Northern Arizona Proposed Withdrawal Draft Environmental Impact Statement
Comments By Gregory Yount
Manager: The NAU Project, LLC
Chapter 3

Figure 1. Simplified Diagram of U_3O_8 Supply Within the U.S.

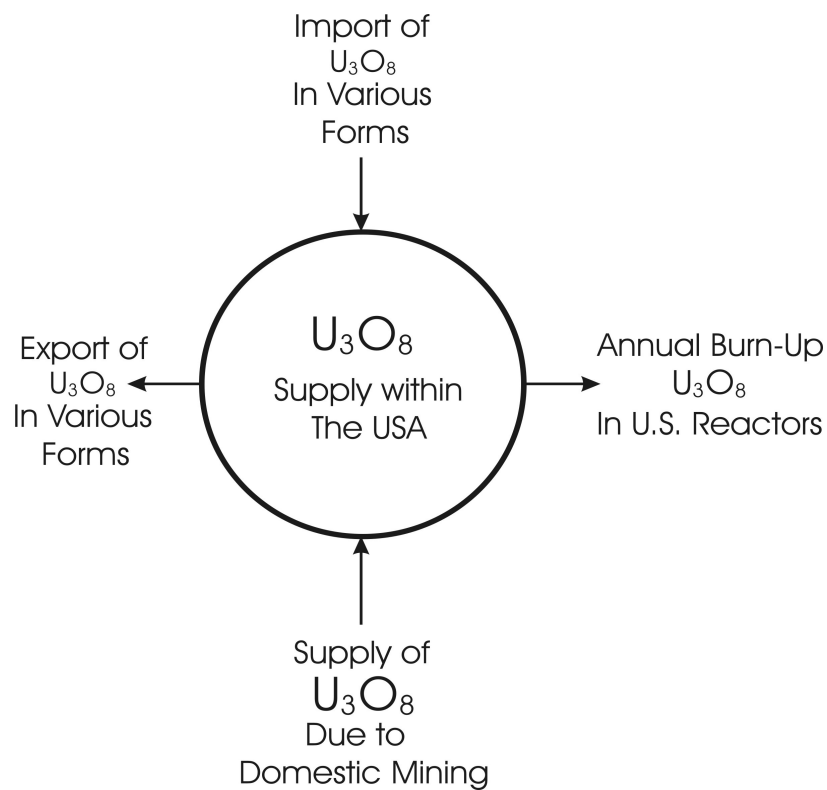
For this exercise, we will assume that the annual burn-up of uranium in U.S. Nuclear reactors is a constant. Current US imports of Uranium from foreign sources is 89% of U.S. Reactor supply and domestic production from mining is about 8%. The balance of uranium required is made from inventories on hand or secondary non-production domestic sources.

Due to the fact that uranium is a fungible commodity, once this uranium enters the U.S. Supply inventory it is indistinguishable as to source and is traded freely within this market place. So the question is this, if you were to stop imports and exports of uranium in the above system, what would be the amount of future uranium supply available to be used in U.S. Nuclear Power Plants? Given this situation, the answer would be 8% of U.S. Reactor requirements could be met. Now lets consider an alternative scenario, U. S. domestic supply from mining was increased to 30% of U.S. Reactor needs. This supply enters the marketplace and is traded freely within that marketplace. Some of it

will surely be exported, but since it is indistinguishable from other uranium in the marketplace it could just as well be uranium that was *imported* to the US supply inventory that was exported. Once in the supply inventory, there is no difference as to origin. The important point is that the over all **supply** of uranium in the U.S. has increased.

Now, under this scenario, if you were to stop imports and exports of uranium, the percentage of future supply available to U.S. Nuclear Power Plants is 30%, or an increase of 22% over the previous example. Therefore, the additional uranium mined and produced in the United States has absolutely moved the United States toward energy independence. The DEIS proposition to the contrary has been proved **false**. This proposition holds true until domestic production equals U.S. Reactor requirements.
